LINCOLN/LANCASTER COUNTY PLANNING STAFF REPORT

P.A.S.: Waiver of Design Standards #02014

PROPOSAL: To waive the design standard for parking lots which requires 15 feet of site penetration.

PROPOSED PARKING LAYOUT

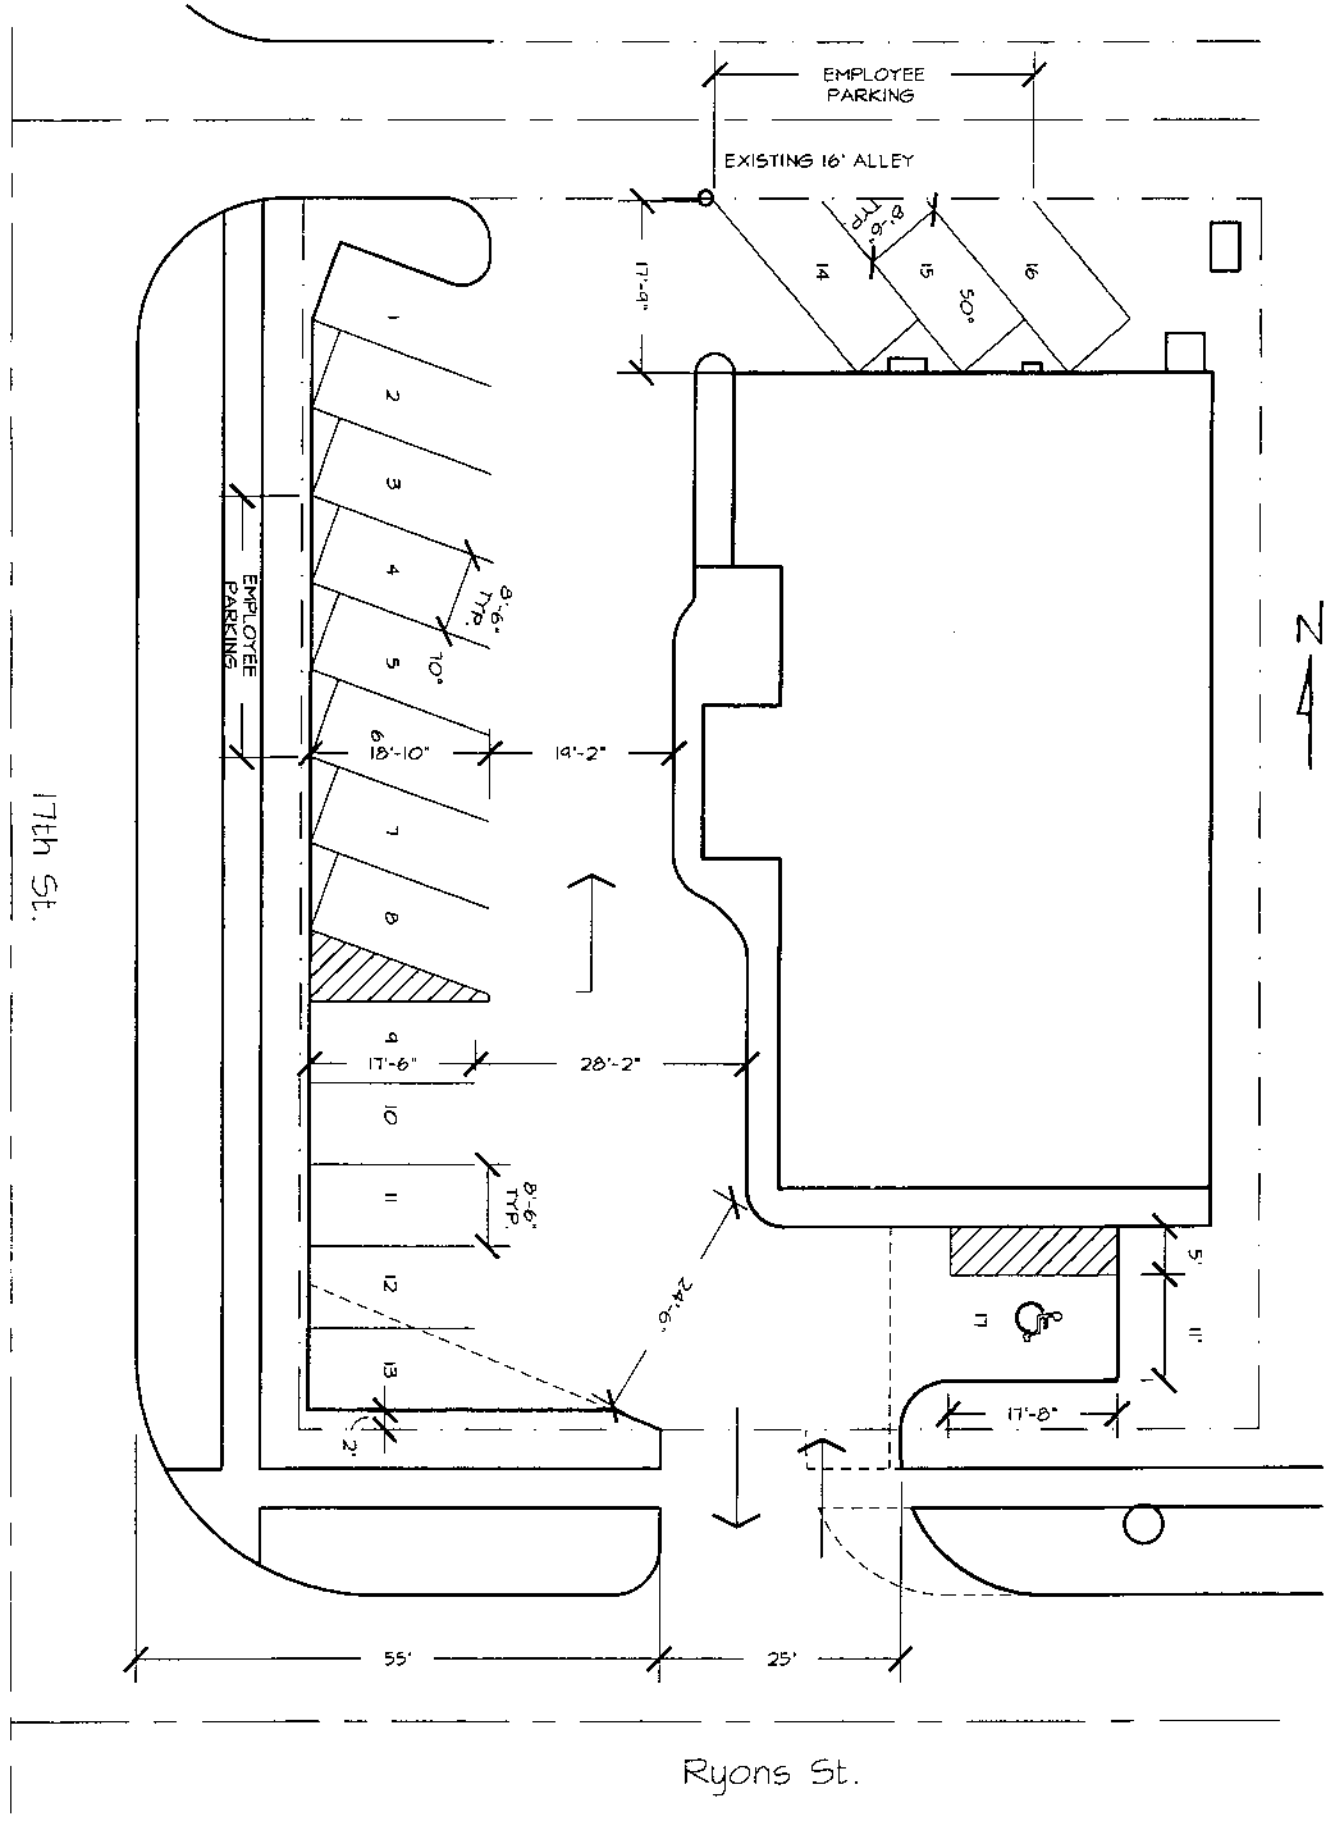
CONCLUSION: If this waiver were granted, cars may need to back over the sidewalk in order to exit the parking lot. This does not protect the health, safety or welfare of pedestrians.

4. The applicant's proposed parking layout creates a situation where cars may need to back over the right-of-way and the sidewalk in order to exit the stalls. This presents a potential hazard for pedestrians.
5. Public Works & Utilities recommends that the applicant revise the parking lot flow to provide one way southbound travel. If the flow were designed so that cars move from north to south, the site penetration requirement would no longer apply.
6. The applicant could also petition the Board of Zoning appeals for an exception to the parking requirements. If approved, the exception would allow the applicant to redesign the lot with fewer stalls so that the site penetration requirement could be met.
7. Parks & Recreation has requested a landscape plan for the parking lot. The landscape plan is not necessary at this time - it will be reviewed with the building permit request.

1. Public Works objects to the waiver. The intent of the requirement is so that vehicles enter and leave the right-of-way across the sidewalk at approximately a right angle. The design submitted shows stall that cannot be accessed and meet this principal. Depending upon the direction of travel, cars may need to back over the right-of-way and potentially over the sidewalk to exit the stalls. No justification is given other than that the site is too small for the use intended.
2. I recommend that the parking lot flow be reversed to provide one way travel southbound. The site penetration design standard would than not be an issue.

1. Please provide a landscape plan for review depicting existing and proposed plant materials. Include the location of existing/proposed street trees as well.

Other solutions are possible. The parking lot could be redesigned to provide one way southbound travel. If all cars were exiting onto Ryons Street in a forward motion, the site penetration requirement would no longer apply. The applicant could also request an exception to the parking requirements from the Board of Zoning appeals, build fewer stalls, and meet site penetration requirements.
